**HISTORIC PRESERVATION COMMISSION
REGULAR MEETING
THURSDAY, APRIL 22, 2021
ASSEMBLY HALL
395 MAGNOLIA ROAD
PINEHURST, NORTH CAROLINA
4:00 PM**

A. COA 2021-00052 (1 Carolina Vista)

To: Historic Preservation Commission
From: Kathy Liles, Senior Planner
Alex Cameron, Principal Planner
CC: Darryn Burich, Planning and Inspections Director
Jill Lazusky, Administrative Assistant
Date: May 20, 2021
Subject: Major COA Request for 220 Cherokee Road

Sketch plan

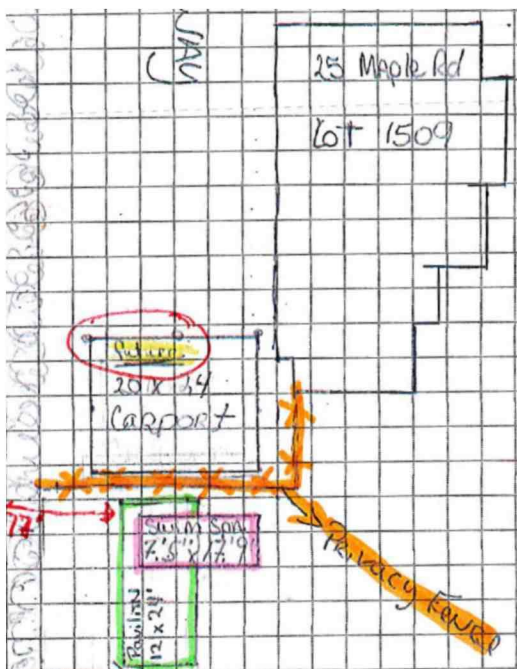
The proposed white painted fence is not compliant with the guidelines as a solid fence. The proposed fence is also street facing. Solid privacy fences are not permitted in the district. At 6' in height, which is compliant with Section VII.A.11, the rear yard fence will shield the swim spa from sidewalk and street visibility. By shielding the spa, the fence sacrifices the characteristic of being open. The applicant has provided a photo of a neighbor's solid wooden fence as evidence that solid wood fences exist in the historic district.

Existing first floor plan with proposed removal

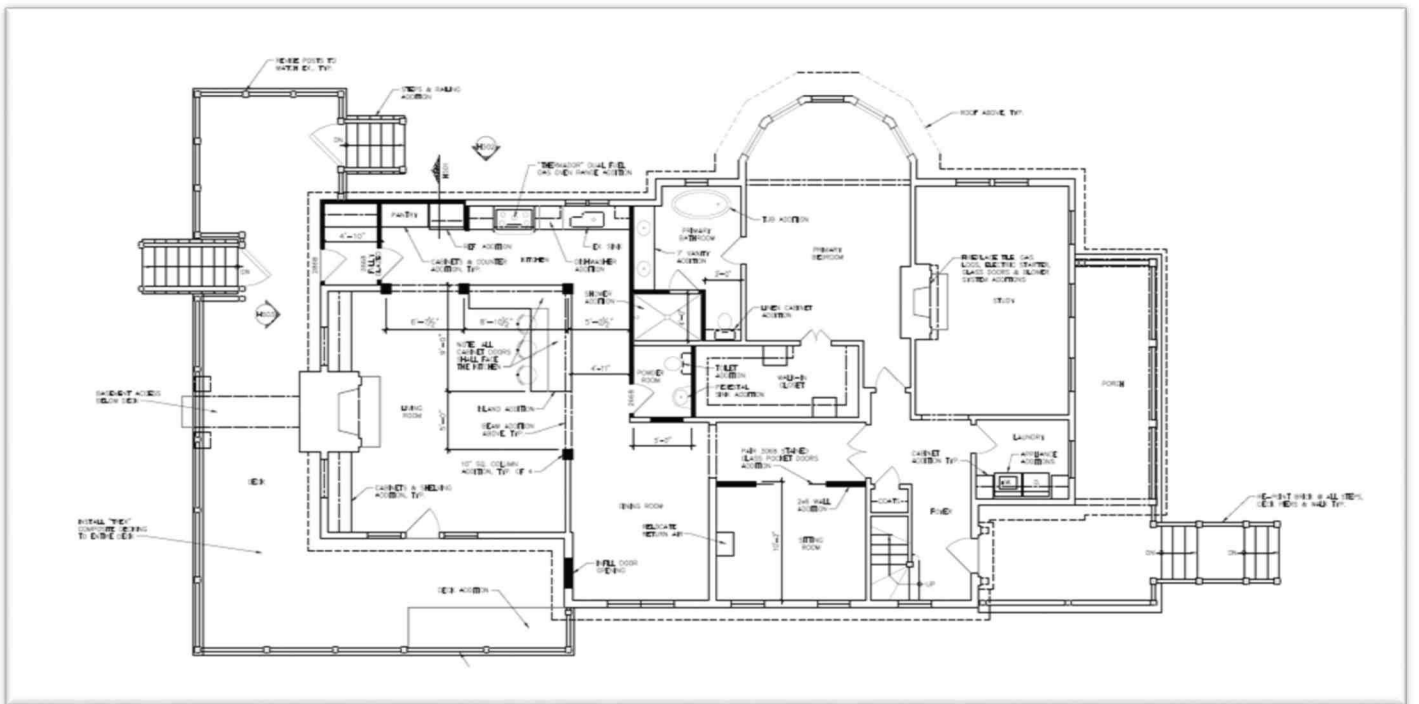
The applicant proposes to infill the door opening on the left side of the house and remove a door to expand the kitchen on the rear of the house replacing it with a new door of the same style. The front door is to be repainted. The door area to be removed is to be resided to match the existing residence. The material changes would be compatible with the existing structure, not visible from the street and congruous with the district.

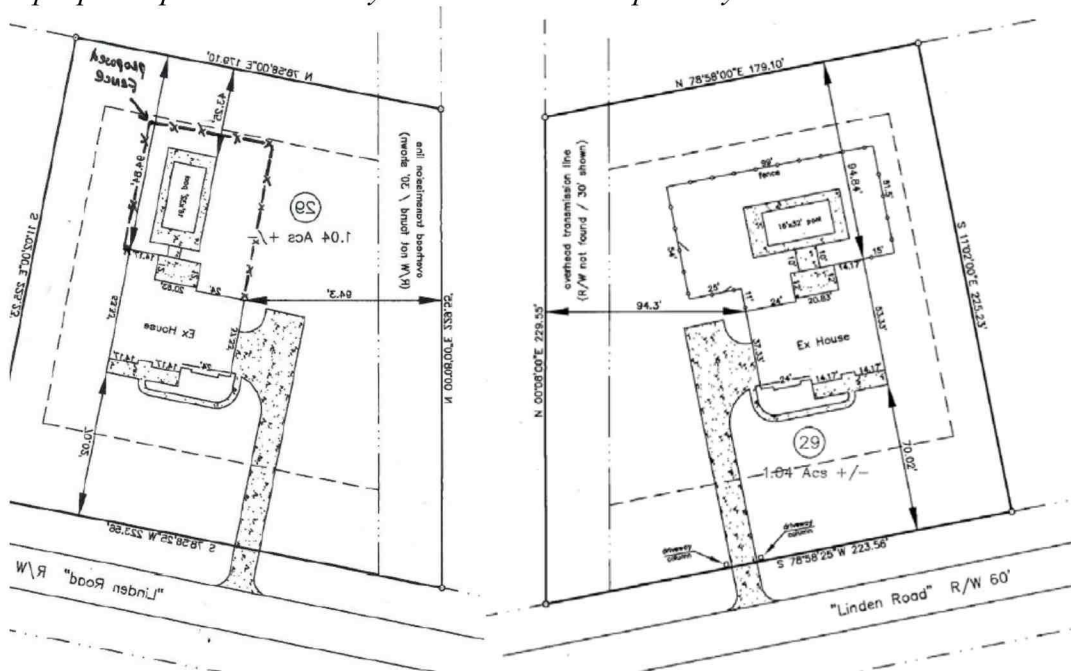
The proposed in-ground pool appears to be similar to other in-ground pools located within the Historic District.

Proposed brick column and lantern detail

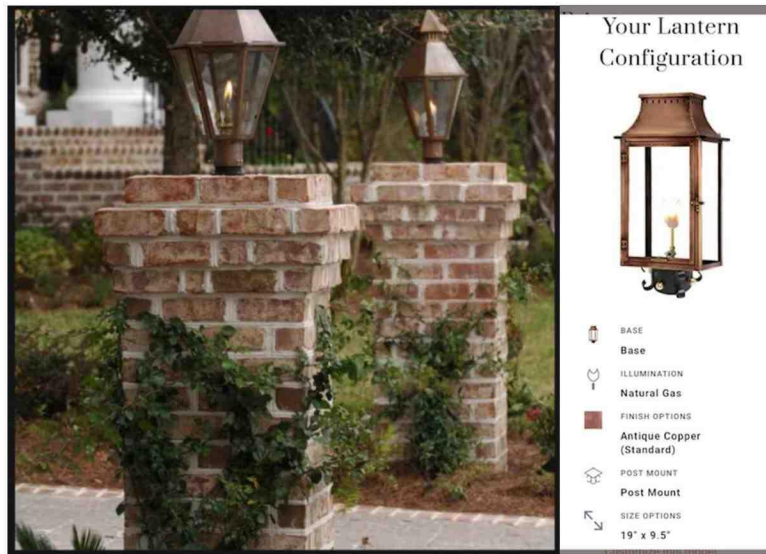
The columns are proposed to be located at the driveway entrance and topped with gas lanterns. The proposed columns are 3 feet tall with a 2 foot square base. The gas lanterns are proposed to top the columns and will be within the 5 foot height requirement of the PDO. These columns are compliant with the PDO and meet the applicable guidelines.

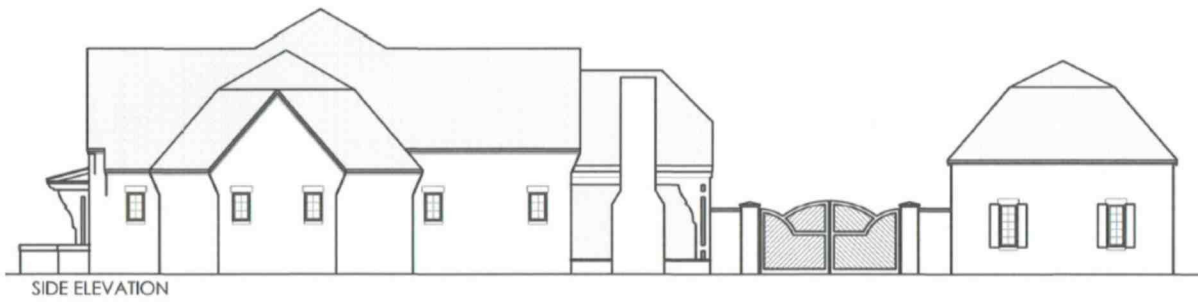
The proposed detached garage is compatible with the proposed primary structure.

The proposed detached garage is lower in height than the tallest pitch of the primary structure.
